**SECTION 00 90 02  
BIDDING AND CONTRACT REQUIREMENTS  
ADDENDUM NUMBER (2)**

**Re: ADDENDUM NUMBER (2) TO THE BIDDING DOCUMENTS FOR**

**Illinois Valley Community College  
Building F AHU & Building J Exhaust Upgrades  
Architect's Project Number: 20-005**

SHEET NUMBER:  
**M2.02**

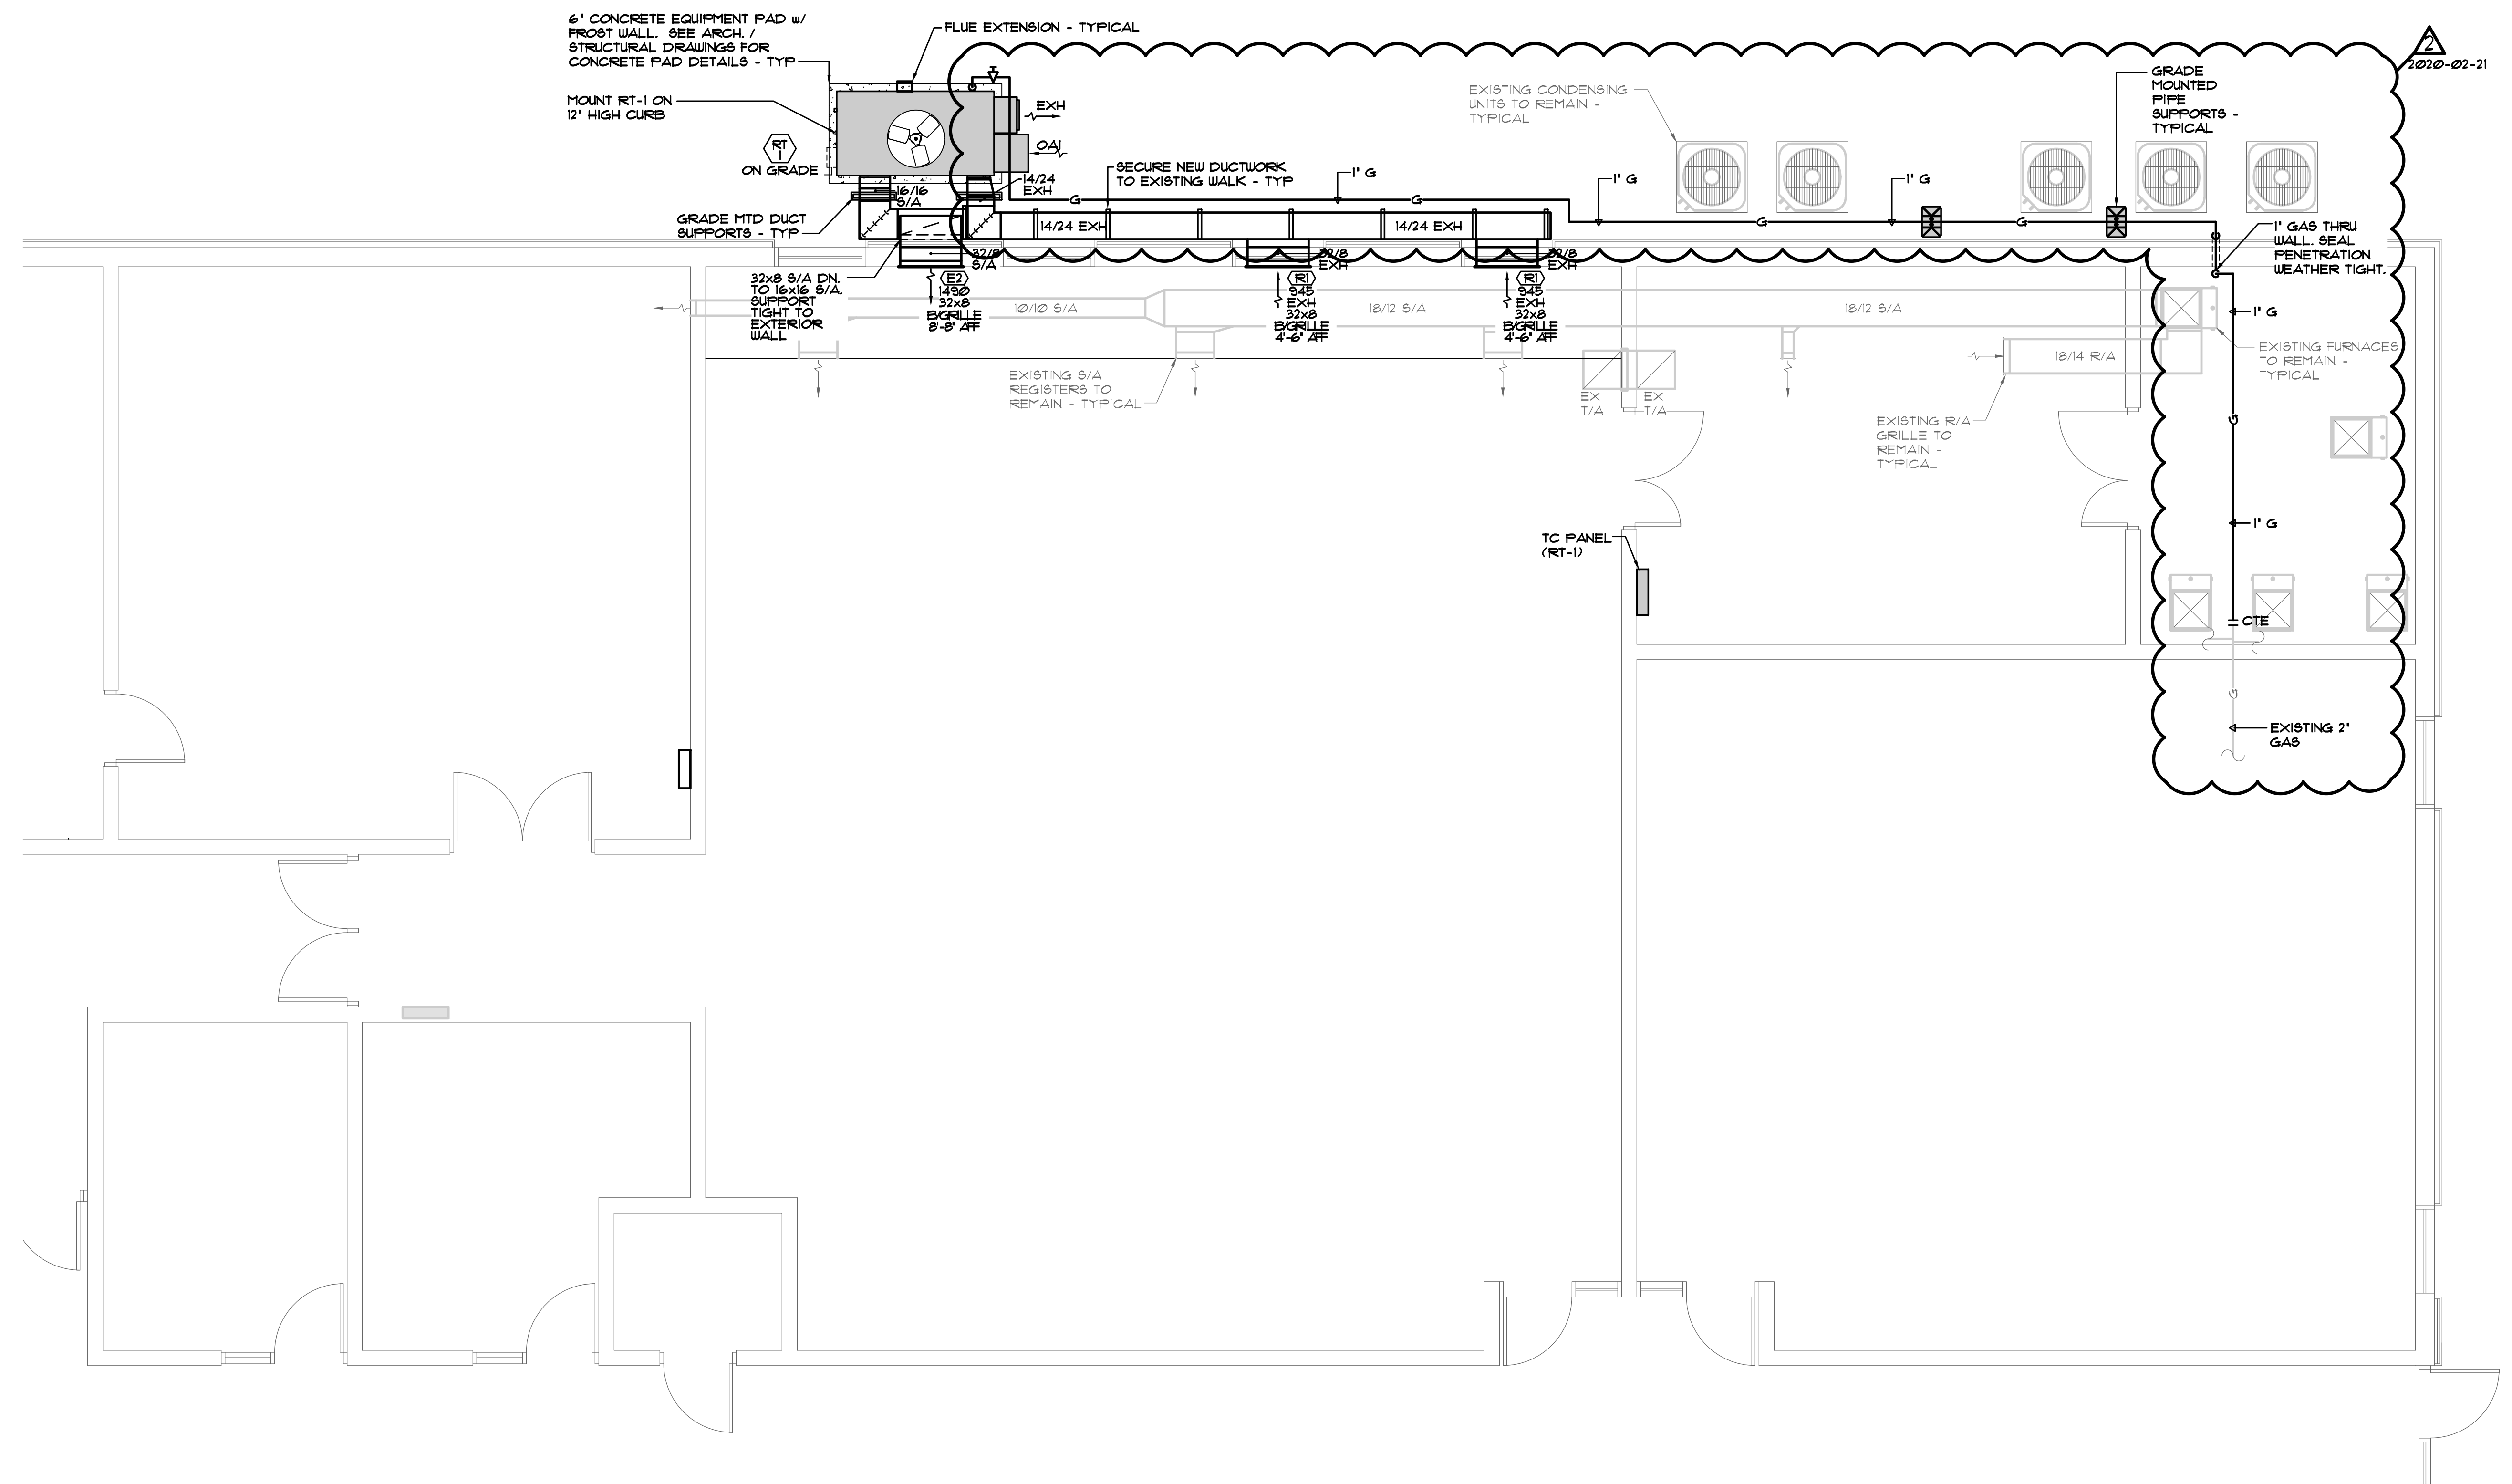
1. Drawing M2.02 – Building J Main Floor Plan – Mechanical New Work
  - a. **ADD** gas piping for grade mounted rooftop unit RT-1. See attached sheet M2.02.
